Access Compliance Report

Public Rights-of-Way

(Curb Ramps)

Intersection ID: N/A	Main Street: GLENBURN_LN	Cross Street: DULNIAN_WY	Location: NE
ADA ID: 750F7D9957B8	Ramp Type: PerpDiag	Initial Pass/Fail: Fail	Overall Compliance: No
		Severity Score: 8.75

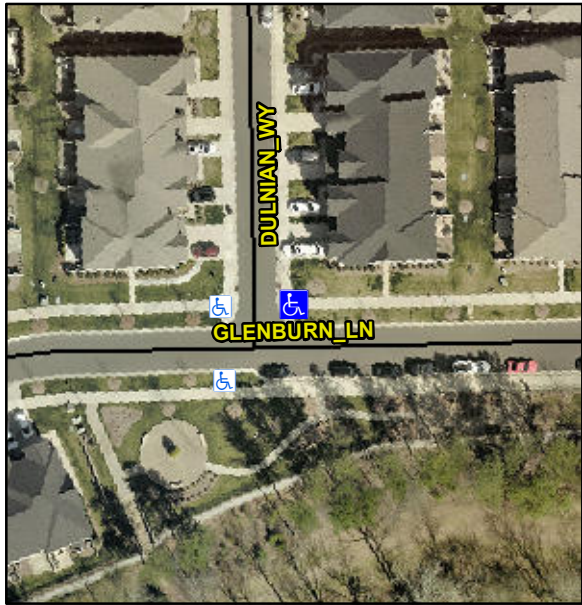
Codes/Mitigation Info/Possible Solution			Field Measurements/Component Compliance					
	Possible Solutions:		Compliance	Description	Data	Compliance	Description	Data
	Remove & Replace Curb Ramp With Two New Directional Ramps or Equivalent.		N/A	Ramp Length (in)	83.0	Yes	Ramp Slope (%)	6.8
			No	Ramp Width (in)	47.0	Yes	Ramp XSlope (%)	0.9
			N/A	Flare Type LT	N/A	N/A	Flare Type RT	N/A
			N/A	Flare Slope LT (%)	N/A	N/A	Flare Slope RT (%)	N/A
			N/A	Flare Traversable LT?	N/A	N/A	Flare Traversable RT?	N/A
			N/A	Landing Length (in)	N/A	N/A	DWS Provided?	N/A
			N/A	Landing Width (in)	N/A	N/A	DWS Contrast?	N/A
			N/A	Landing Slope (%)	N/A	N/A	DWS Length (in)	N/A
			N/A	Landing X Slope (%)	N/A	N/A	DWS Full Width?	N/A
Surveyor Notes:	N/A		N/A	Landing Curb? (Y/N)	N/A	N/A	DWS Offset (in)	N/A
			N/A	Shared Landing?	N/A			
			N/A	Gutter Ponding?	N/A	N/A	Gutter Slope (%)	N/A
			N/A	Gutter Lip Ht (in)	N/A	N/A	Gutter X Slope (%)	N/A

N/A	Painted X Walk1?	No	N/A	Painted X Walk2?	No
				X Walk 1 Direction	To E		X Walk 2 Direction	To S
			N/A	X Walk 1 Width (in)	N/A	N/A	X Walk 2 Width (in)	N/A
				X Walk 1 Slope (%)	0.1		X Walk 2 Slope (%)	1.1
				X Walk 1 X Slope (%)	0.7		X Walk 2 X Slope (%)	0.3
			N/A	Ramp inside XWalk1?	N/A	N/A	Ramp inside XWalk2?	N/A
PROW/ADA:	Not Found, R304.5.1			Road Slope (%)	1.4	N/A	Clear Space?	N/A
				Road X Slope (%)	0.2	N/A	Clear Space to XWalk (in)	N/A
			N/A	Any Obstructions?	N/A	N/A	Storm Grate/Utility Hazard?	N/A
				Obstruction Type			Storm Grate/Utility Type	
					N/A			N/A
						Yes	Surface Condition? (G/P)	Good
Total Cost:		\$	3200.00
